"Increasing channel capacity of the
River Opava in Krnov and
incorporation of the river into the urban
structure of the town"

Review of Report

Ir. H.J.M. Ogink

July, 2006

Figure 4-1 Q_{100} water level profile in Opava at Krnov for alternatives V0 and V1

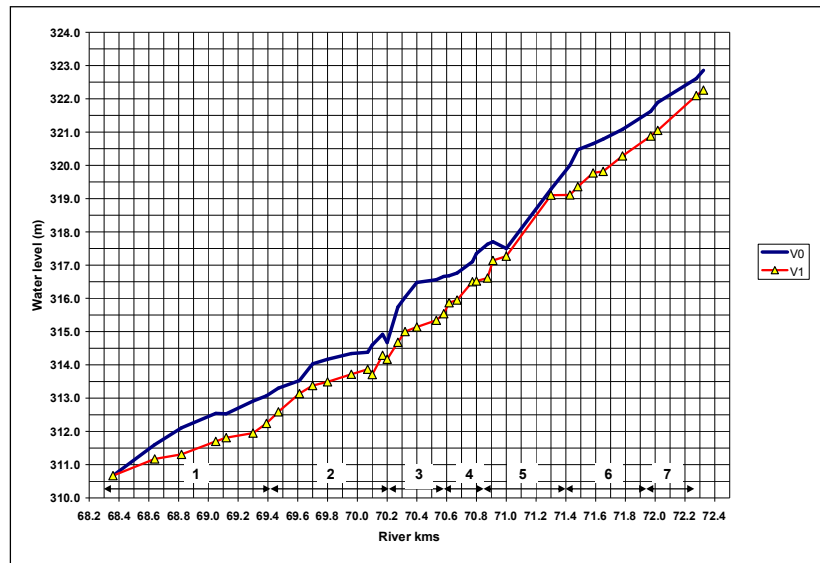
The 100-year flood water levels as calculated are presented in Table 4-2. In Figures 4-1 and 4-2 a comparison is made between the extreme alternatives V0 and V1. The effect of widening of the river cross-sections (V1) compared to raising of the banks (V0) on the design water levels is visible from the graphs. In all sections but Section 5 the reduction in design water level appears to be considerable. From the water table calculations it is observed that at some bridge locations, due to constriction, the velocity head effect may be large causing the water level to fall locally in upstream direction. Cross-sectional details are missing to assess this in detail.

Figure 4-3 Difference between Q_{100} water level profile of alternatives V21 and V0

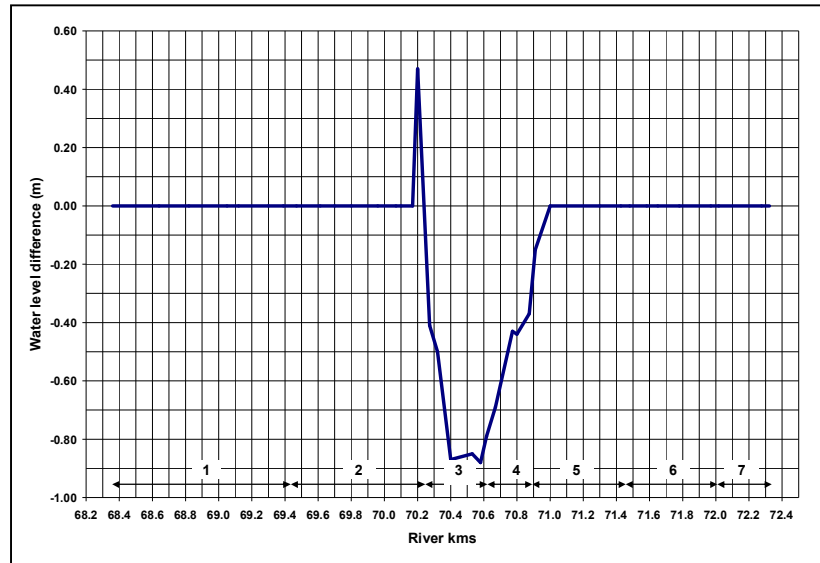
The alternatives V21, V22 and V23 are mixtures of V0 and V1. The water level differences of each of the variants with V0 are presented in the Figures 4-3 to 4-5. From the modifications presented in Table 4-1 for alternative V21 in Section 3 a lowering of the design flood level may be expected, for alternative V22 in the Sections 3 and 5 and for alternative V23 in the Sections 1, 3, 5 and 7. From the Figures it is observed that at least qualitatively these alternatives have correctly been calculated. A hick-up is observed for km 70.2 which needs further attention in the calculations. Furthermore, the results of alternative V22 and V23 in comparison with V0 requires further attention as to the modelling of the weir at km 71.0, see Figures 4-4 and 4-5.
